## Rozelle Interchange Urban Design and Landscape Plan: Community consultation feedback and response overview

August 2021

Figure 4-5: EIS Design compared with UDLP

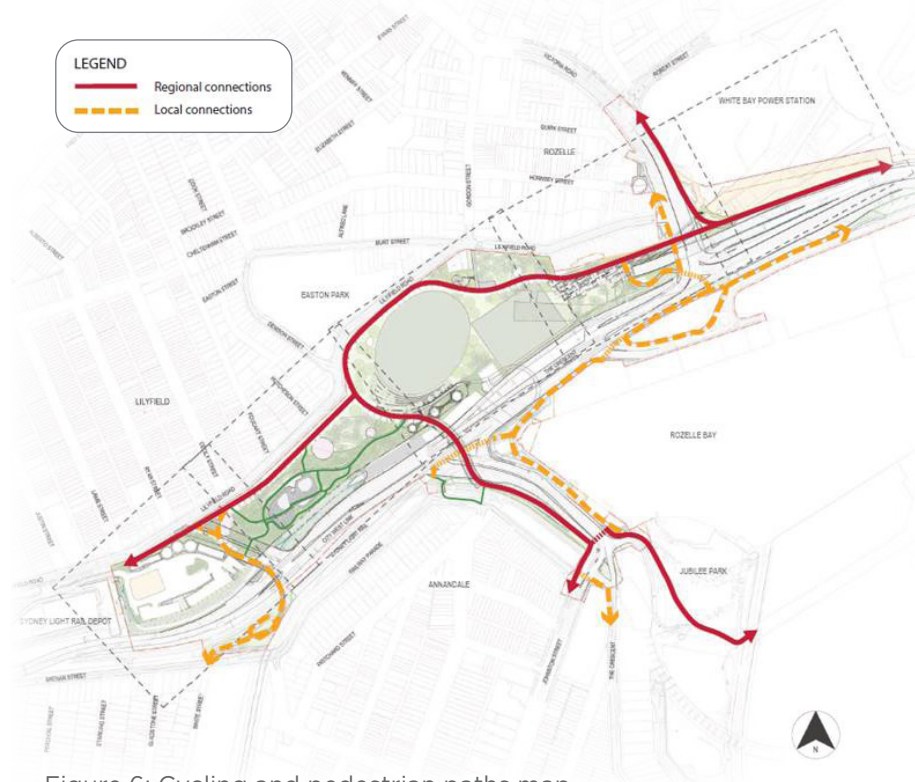
A significant number of community comments requested design changes to the ventilation outlets at both Rozelle Parklands and Iron Cove Link. Some suggestions included cladding the outlets in sandstone or incorporating a mural to represent the Aboriginal heritage of the area.

In relation to the Rozelle Parklands ventilation facilities, the UDLP design is a significant improvement to the initial design proposed in the Environment Impact Statement (EIS) submitted in 2017. We have been able to move ventilation supporting structures underground to free up a significant new area of green space above ground.

The design of the ventilation facilities was undertaken by our expert designers and endorsed by the DRP. It is not proposed to change the design of the Rozelle Parklands ventilation outlets.
